UNITED STATES PATENT AND TRADEMARK OFFICE

APPLICATION NO.	FILING DATE	FIRST NAMED INVENTOR	ATTORNEY DOCKET NO.	CONFIRMATION NO.	
10/053,198	01/17/2002	Chinnugounder Senthilkumar	10559/649001/P12971 2860		
20985	7590 05/23/2003				
	HARDSON, PC LA VILLAGE DRIVE		EXAMINER		
SUITE 500	LA VILLAGE DRIVE		SHINGLETON,	SHINGLETON, MICHAEL B	
SAN DIEGO,	CA 92122		ART UNIT PAPER NUMBE		
			2817	······	
			DATE MAILED: 05/23/2003

DETAILED ACTION

Figure 3 and columns 3 and 4 of Jansson set forth an integrated crystal oscillator apparatus.

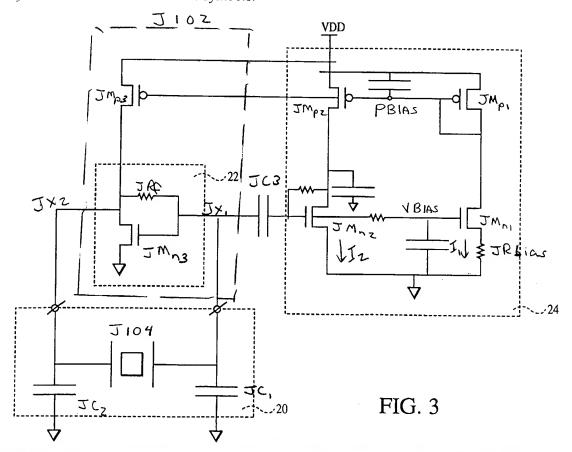
Jansson states: "FIG 3 is described in more detail in the Vittoz article". Thus in accordance with MPEP 2131.01, this 35 USC 102 rejection is based upon both Jansson and Vittoz. Vittoz merely helps explain the meaning of the referenced and unreferenced terminology used in the specification and drawings of Jansson and shows that the characteristics not disclosed in Jansson are inherent. Figure 3 of Jansson does not give reference numerals for each and every element in Figure 3. Therefore, in order for the following rejection to accurately point to item by item in the claims of the instant application and for applicant's case of understanding, the following copy of Figure 3 of Jansson is provided with reference symbols and this rejection refers to these reference symbols.

Note that while Figure 3 of Jansson is not clear on whether the line "PBIAS" directly connects to all the gates of JMp1, JMp2, and JMp3. It is clearly from Vittoz that such is the case.

Figure 3 of Jansson as evidenced by Vittoz discloses an "apparatus" having an oscillator circuit 1100/that is for generating "an oscillating signal" at the terminal JXI. This oscillator circuit 1100 has an inverting amplifier J102 and a resonator J104. The crystal resonator J104 has two terminals, JX1 and JX2, that are connected to input and output terminals, respectively, of inverting amplifier J102, as is clearly shown in Figure 3 of Jansson as evidenced by Vittoz (Also note page 4, lines 15-17 of the instant application and at least claim 2 of the instant application.). Jansson as evidenced by Vittoz also includes a feedback resistor JRf that feeds back a portion of the amplified oscillating signal to the input of the amplifier as clearly shown in Figure 3 of Jansson as evidenced by Vittoz. Jansson as evidenced by Vittoz also provides a "bias circuit" 24. Note this arrangement produces a relatively constant current II flowing through relatively constant current source JMp1 and JMn1, and a relatively constant current I2 flowing through relatively constant current source JMp2 and JMn2 because of the current mirror arrangement of these transistors (Also see Figure 9 of Vittoz). Since all of the structure of the bias circuit 106 of the instant invention is clearly present in Figure 3 of Jansson, the "relatively constant current source", noted above, is "configured to create a relatively constant bias voltage (PBIAS) to bias the amplifier in an operating state that can sustain the oscillating signal" as is inherent in Jansson as evidenced by Vittoz. While Jansson does not identify the operation region of the transistors of the bias circuit and the transistors of the inverting amplifier when an "operation state" is obtained, the transistors of Jansson as evidenced by Vittoz are operated in the weak inversion region when an "operation state" is obtained as evidenced by Vittoz. In particular note page 229 of Vittoz. The "weak inversion" region is also well known in the art as the "sub-threshold region". The relatively constant current source JMp1, JMn1, JMp2, and JMn2 has a first portion JMp1 and JMn1 that produces a relatively constant current I1 and a second portion JMp2 and JMn2 that produces a relatively constant current I2. The "first current" is I1 and the "second current" is I2. Because of the action of the current mirror arrangement of the transistors of Jansson as evidenced by Vittoz, Jansson as evidenced by Vittoz inherently produces a first current that is a substantially fixed ratio to the second current. Also because of the action of the current mirror arrangement of the transistors of Jansson as evidenced by Vittoz, Jansson as evidenced by Vittoz inherently provides the direct current bias voltage on the node "PBIAS" that is electrically connected to the inverting amplifier J102 as clearly shown in Figure 3 of Jansson and also because of this action of the current mirror arrangement of Jansson as evidenced by Vittoz this bias voltage has a "predefined" relationship with the current flowing through the first portion. The specification does not identify which

component provides for "negative feedback in response to a change in the amount of current flowing through the second portion", however, because Jansson as evidenced by Vittoz has all the same structure for what the examiner believes is the "second portion" (See the above lack of antecedent basis in the specification for this terminology.) one of these components inherently provides for "negative feedback in response to a change in the amount of current flowing through the second portion".

As noted above the relatively constant current source 24 of Jansson as evidenced by Vittoz produces a bias voltage PBIAS. This bias voltage is applied at the node where PBIAS is shown in the above Figure. Thus, Jansson as evidenced by Vittoz clearly includes a "bias node" PBIAS and the relatively constant current source 24 is configured to create the bias voltage PBIAS at the bias node PBIAS. As recognized by Jansson as evidenced by Vittoz the capacitor JC3 in combination with the transistors of element 24 and voltage source Vdd provides for an amplitude regulation during start-up and provides an excitation circuit as recognized specifically on page 229 of Vittoz. This excites the bias circuit to start operation and provide a stable bias voltage. Thus the capacitor JC3 in combination with the transistors of element 24 and the voltage source Vdd forms an "excitation circuit".

Walsh discloses the basic computer arrangement Note Figure 29-1 shows the processor "CPU". the memory "adapted to store data", a "chipset" for managing data transfers between the memory and the processor and an oscillator. Walsh is silent on the exact structure of the oscillator, i.e. clock.

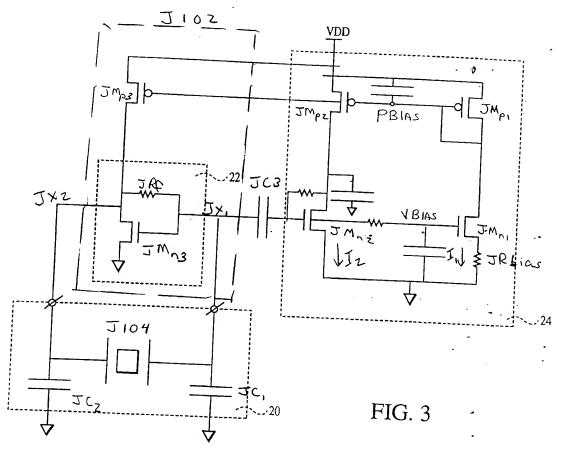
Jansson as evidenced by Vittoz shows the specific structure of a conventional clock oscillator.

Accordingly, it would have been obvious to one of ordinary skill in the art at the time the invention was made to have substituted the conventional clock oscillator for the generic clock oscillator

of Walsh because, as the reference is silent as the specific structure that makes up the clock oscillator, any art-recognized equivalent clock oscillator structure would have been usable therefore such as the well-known, conventional clock oscillator as disclosed by Jansson as evidenced by Vittoz.
